第8回加東市社地域小中一貫校開校準備委員会 【資料1】

基本設計時と実施設計時との比較（R3. 9. 30現在）

R3. 10. 27(水) 19:30～
加東市役所 2階 201会議室

3階平面図

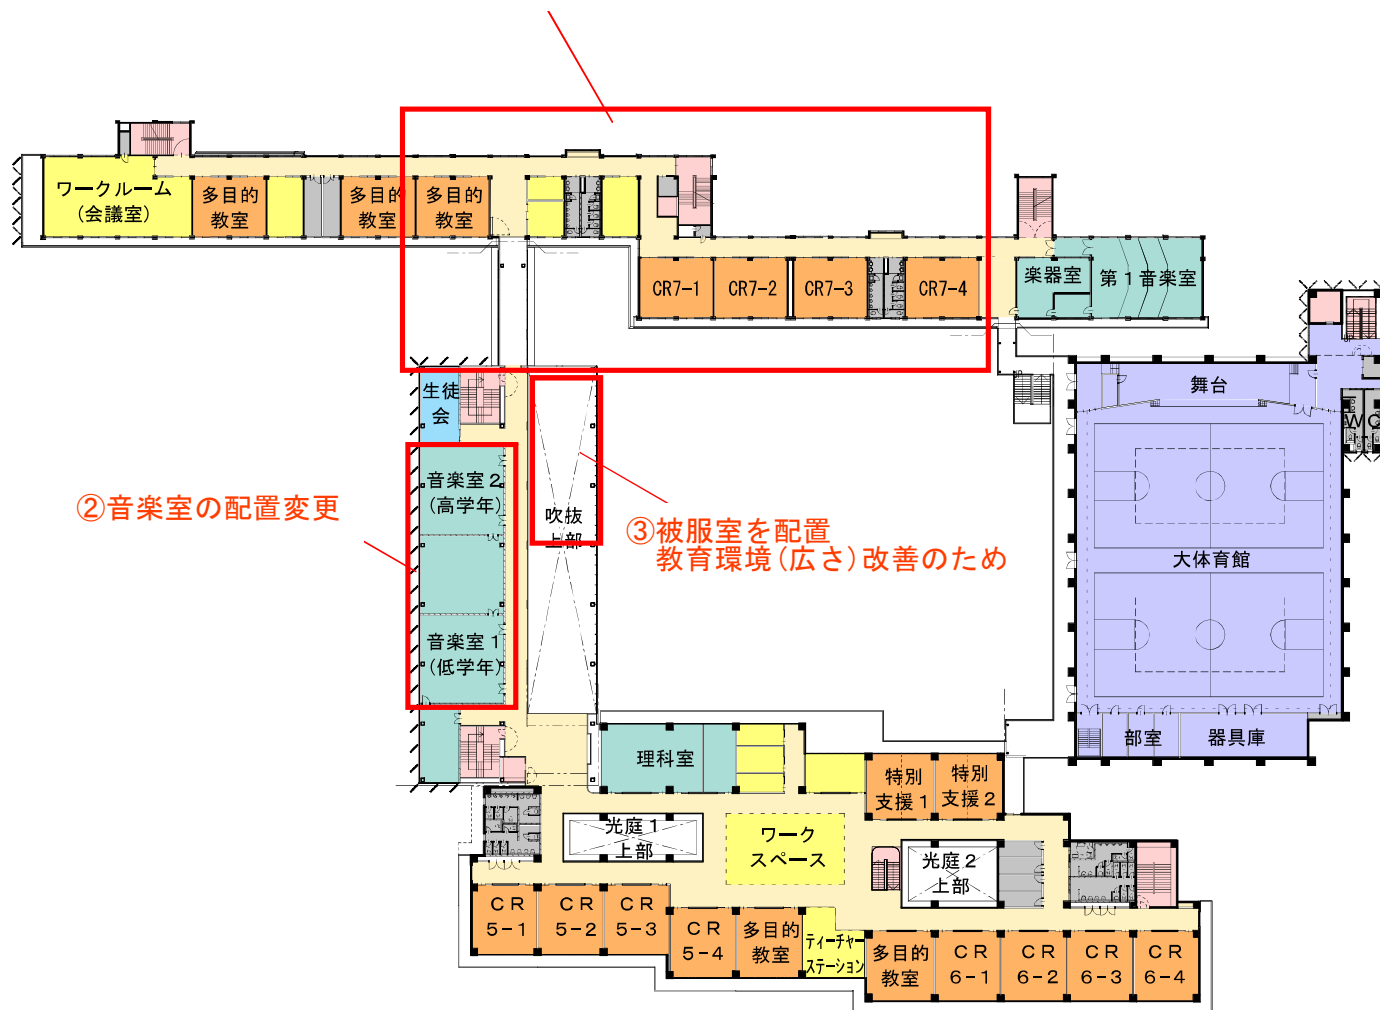
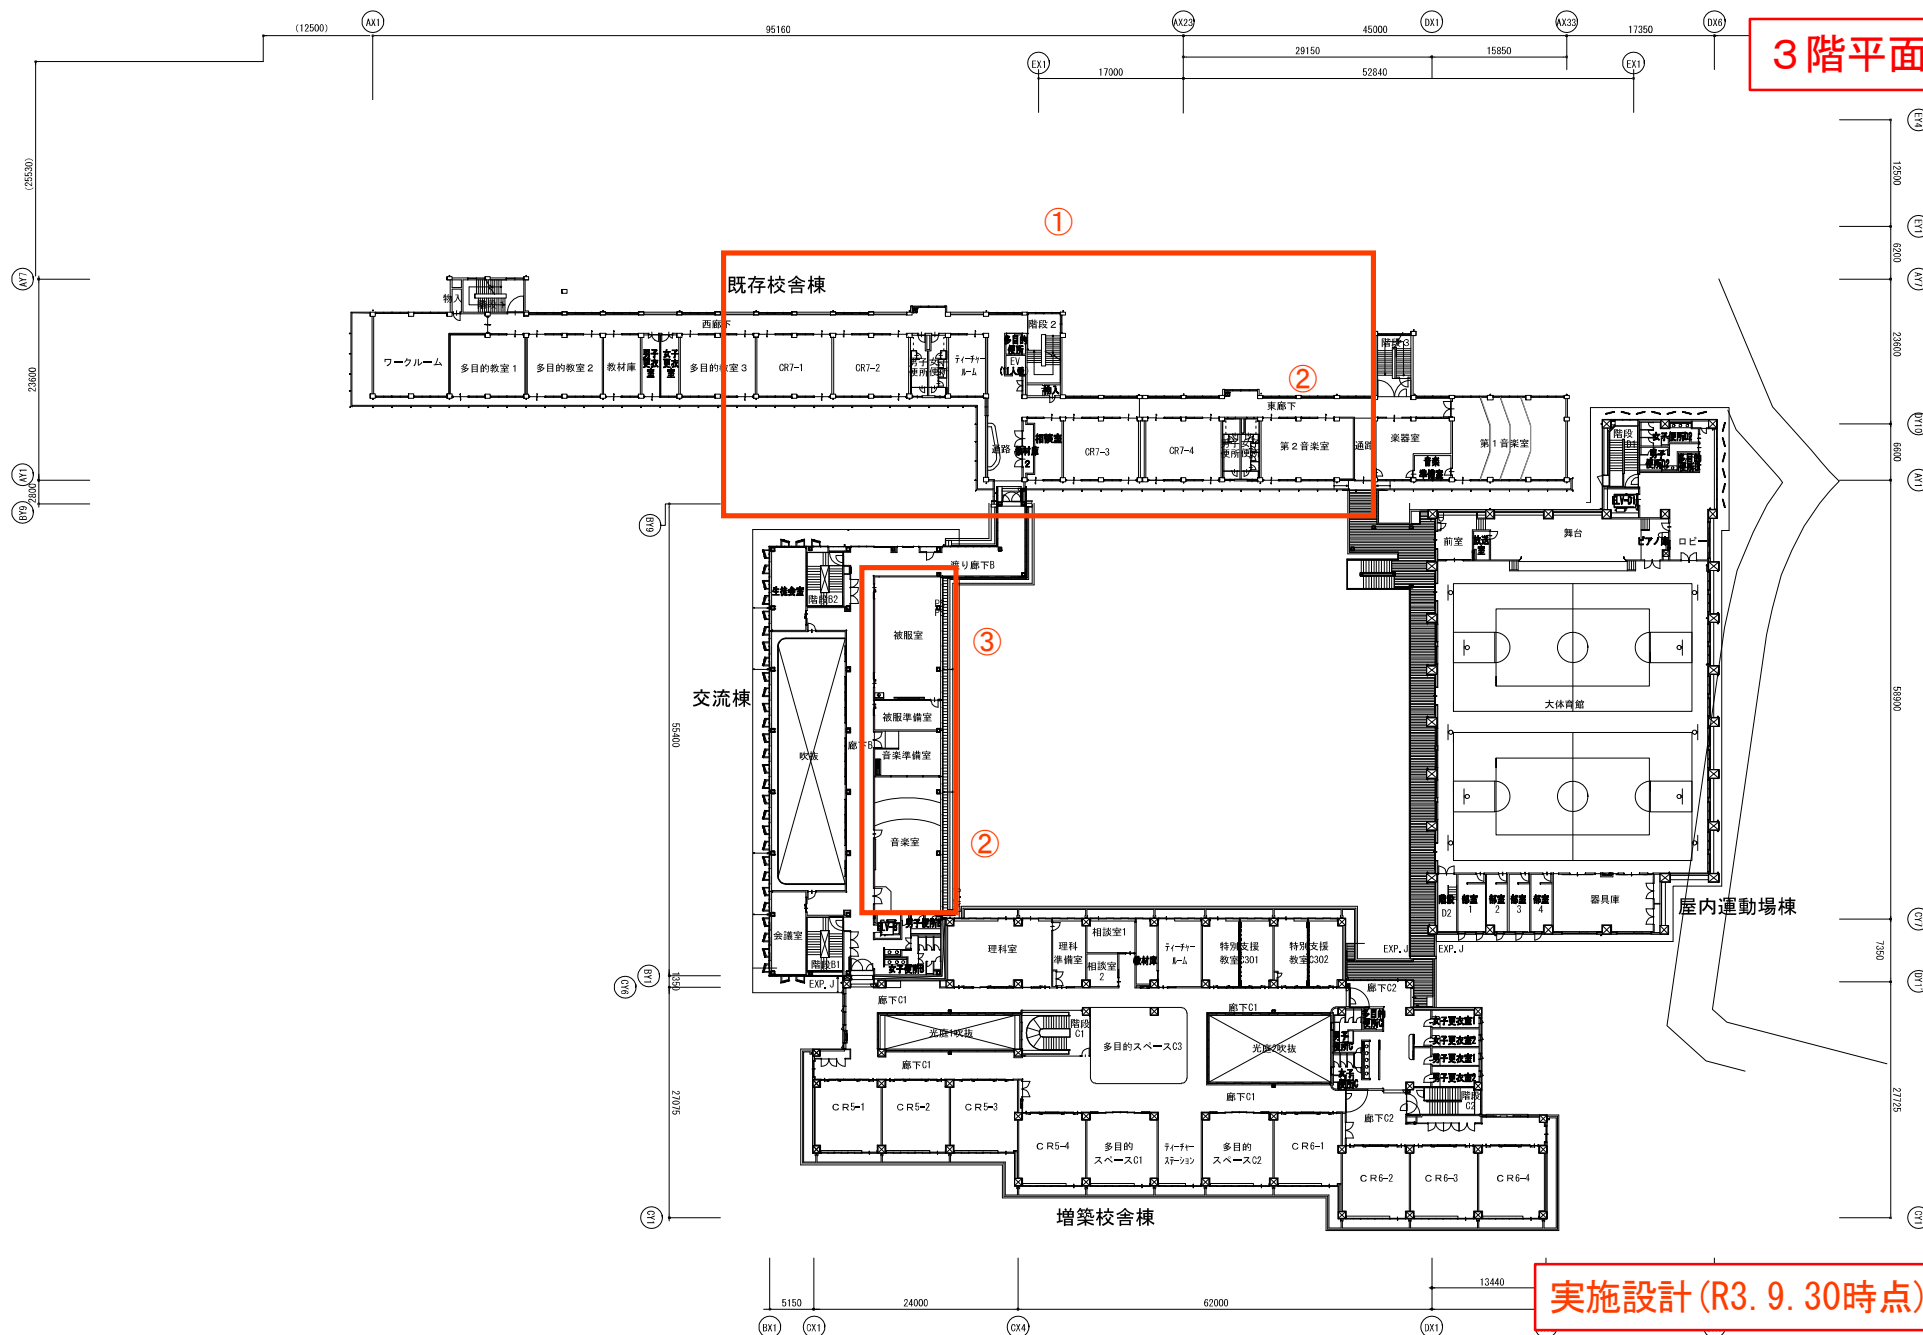
①普通教室の配置と交流棟との渡り廊下接続部の変更、第2音楽室の配置変更
被服室の配置変更のため

②音楽室の配置変更

③被服室を配置
教育環境(広さ)改善のため
